MEMORANDUM FOR: Chairman Palladino
Commissioner Roberts
Commissioner Asselstine
Commissioner Bernthal
Commissioner Zech

SUBJECT: USI A-44, STATION BLACKOUT

The staff has received questions on USI A-44, Station Blackout, from Commissioners Asselstine, Bernthal, Roberts and Zech. The enclosure to this memo provides the staff's response to these questions.

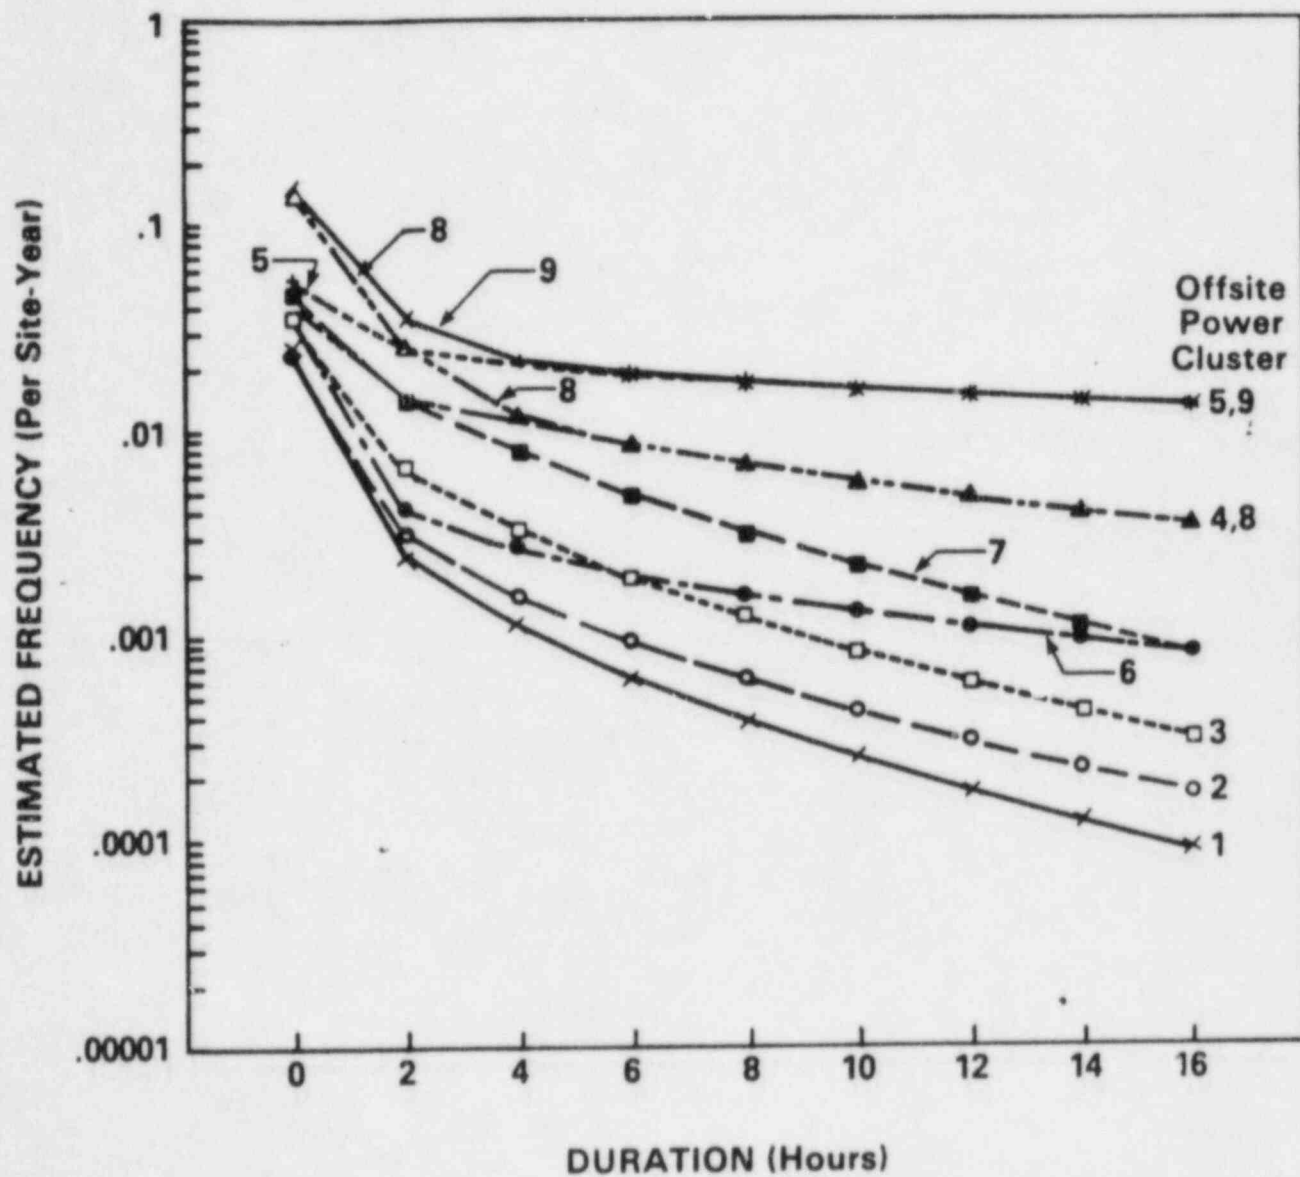
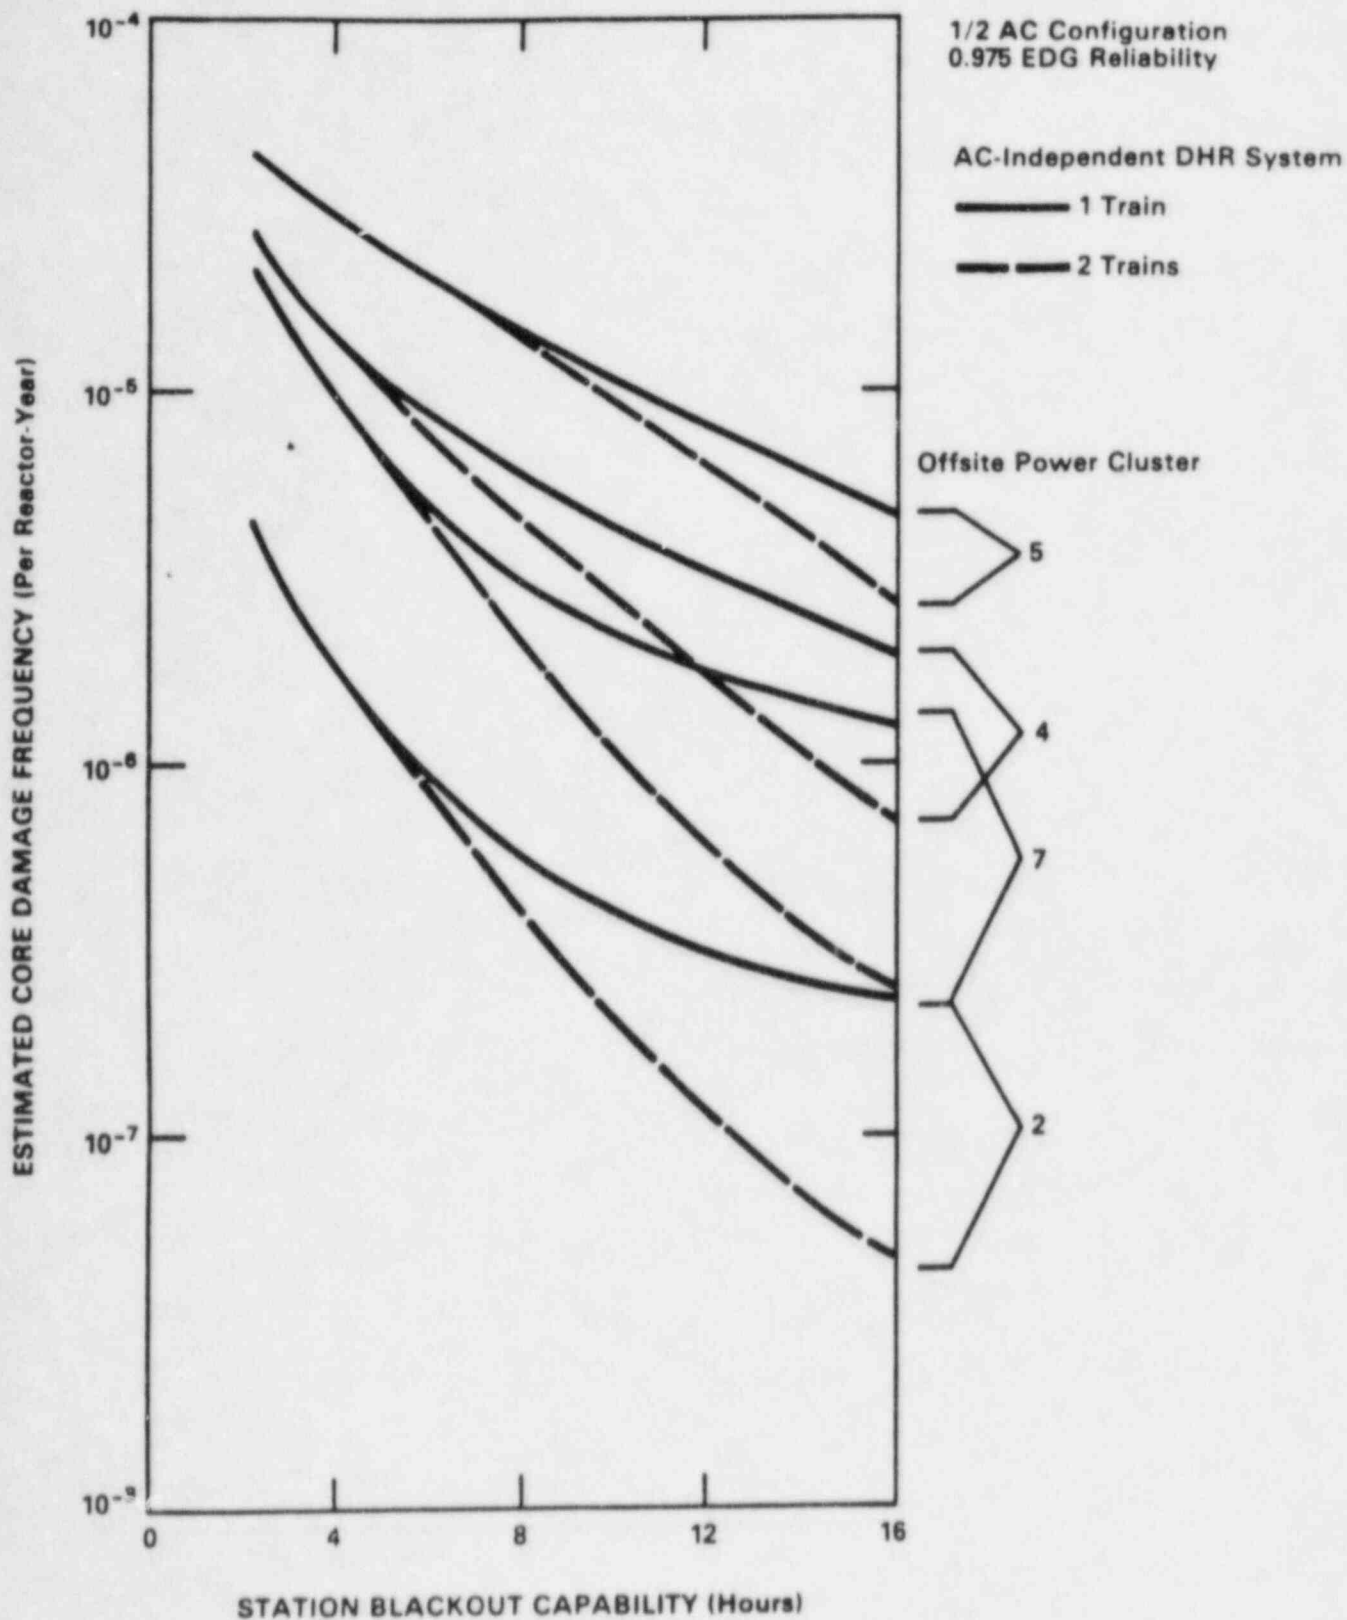
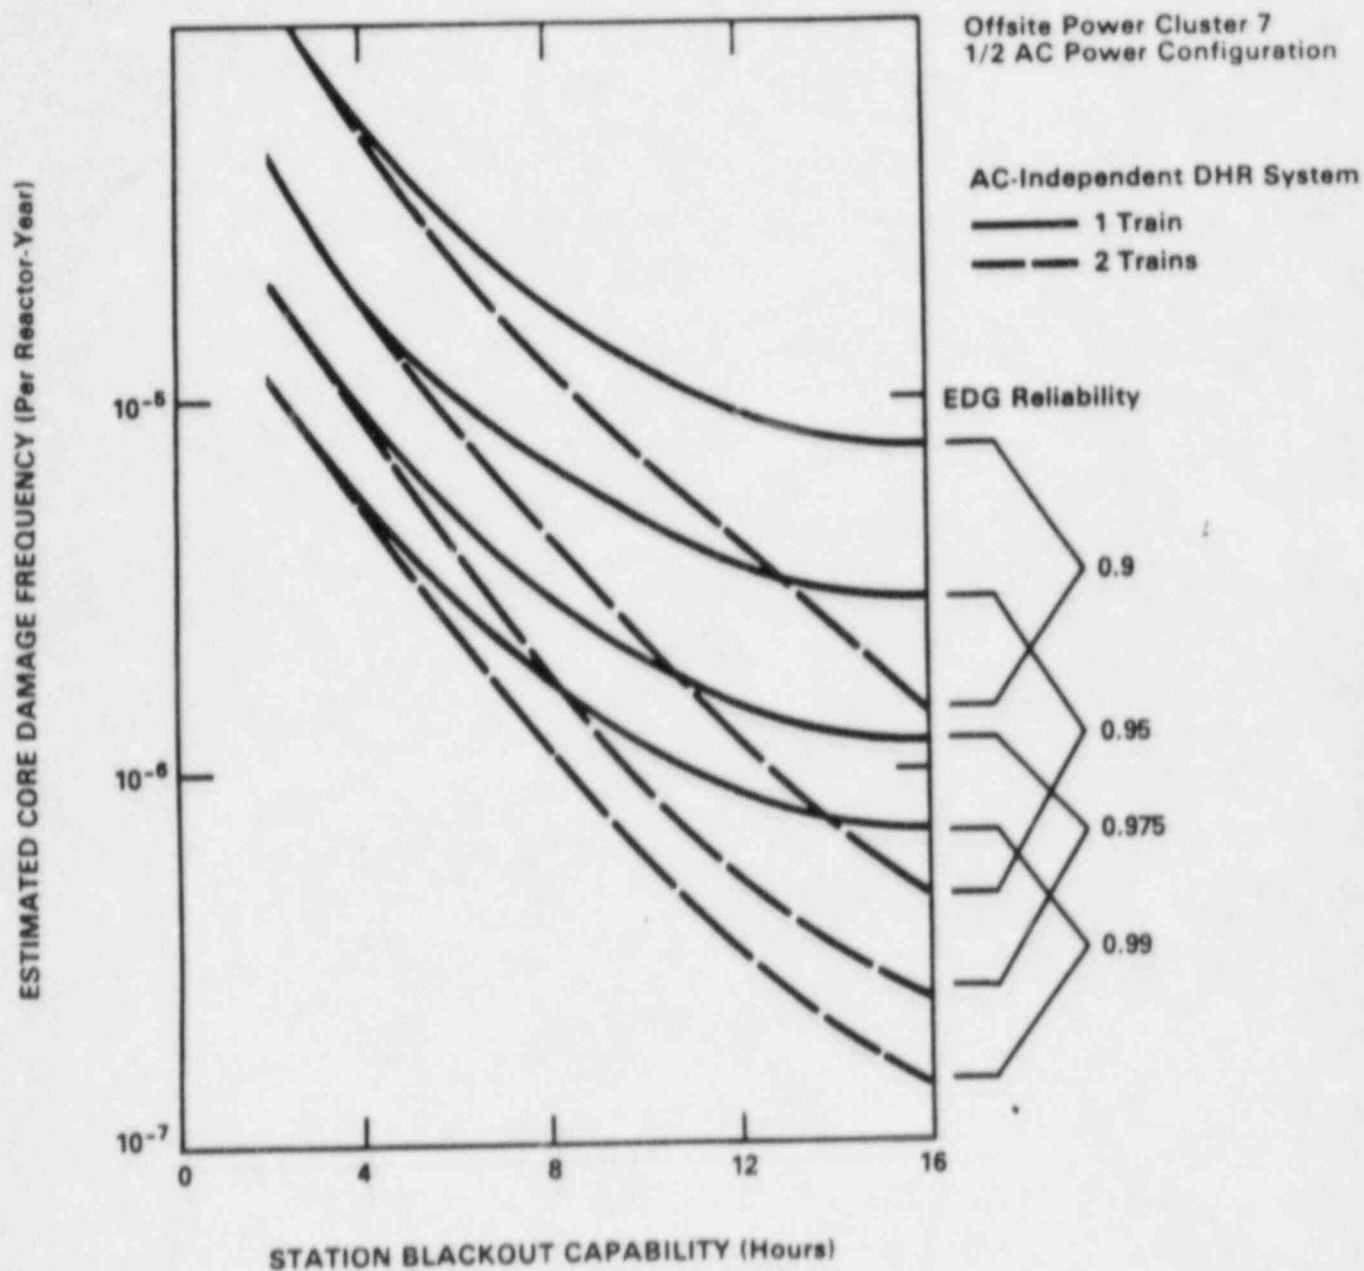
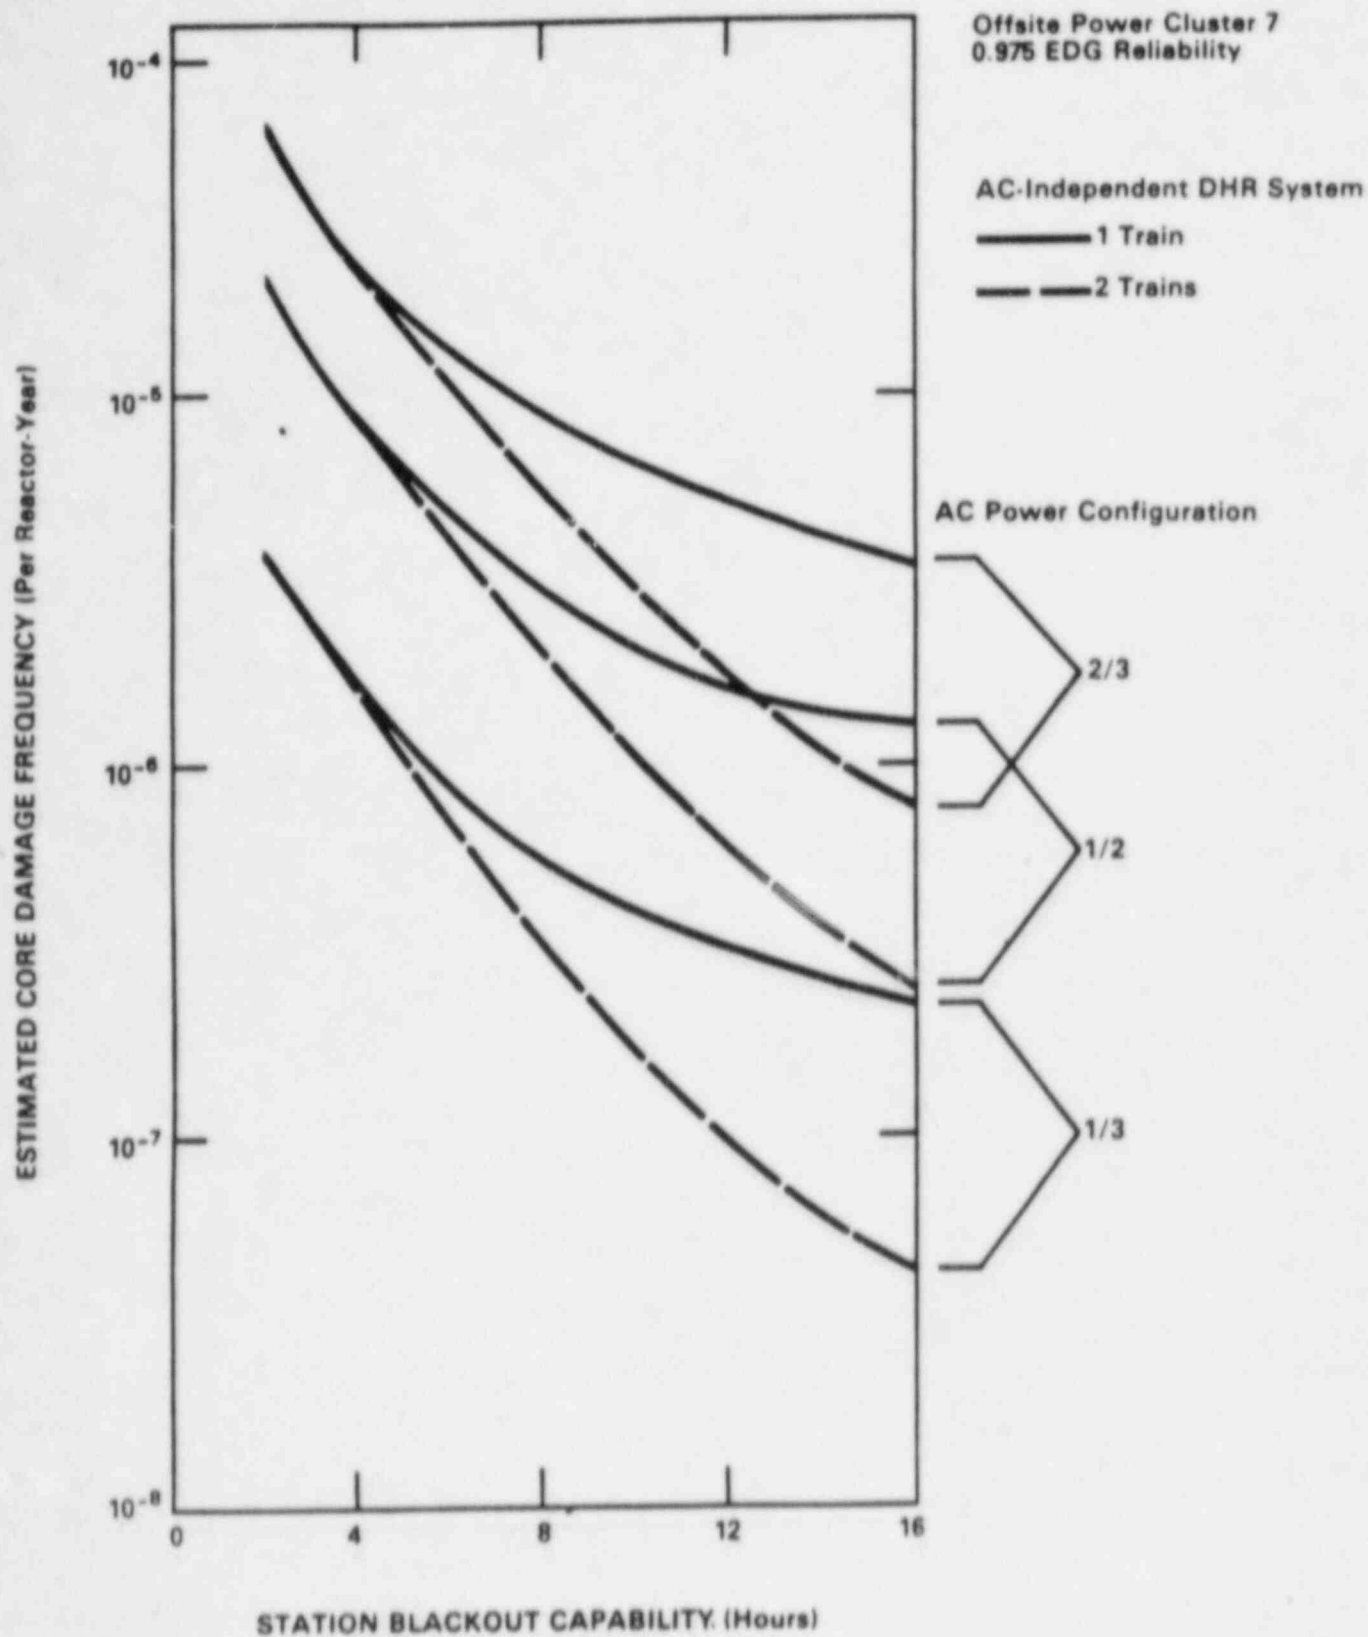
QUESTION 7. PLEASE PROVIDE THE NUMERICAL SCALES FOR THE
GRAPHS ON VIEWGRAPHS 20 AND 26 AND AN EXPLANATION
OF HOW THE UPPER AND LOWER BOUNDS WERE DETERMINED.

THE INFORMATION PRESENTED ON VIEWGRAPHS 20 AND 26 WAS INTENDED
TO CONVEY GENERAL CONCLUSIONS AND WAS NOT INTENDED TO BE
QUANTITATIVE. ALTHOUGH THESE GRAPHS WERE QUALITATIVE IN NATURE,
THEY WERE BASED ON INFORMATION IN APPENDIX A OF NUREG-1032.
VIEWGRAPH 20 WAS INTENDED TO DISPLAY THE RANGE OF DATA ON FIGURE
A-14 WHICH SHOWS THE FREQUENCY OF LOSS OF OFFSITE POWER FOR
DIFFERENT PLANT DESIGN AND SITE CHARACTERISTICS. VIEWGRAPHS 26
IS A COMPOSITE OF THE DATA GIVEN ON FIGURES 8.1, 8.2, AND 8.3
SHOWING THE ESTIMATED CORE DAMAGE FREQUENCY AS A FUNCTION OF
STATION BLACKOUT COPING CAPABILITY AND THREE OTHER PARAMETERS,
OFFSITE POWER CHARACTERISTICS, DIESEL GENERATOR RELIABILITY, AND
DIESEL GENERATOR CONFIGURATION RESPECTIVELY. THE REFERENCED
FIGURES FROM NUREG-1032 ARE ATTACHED.
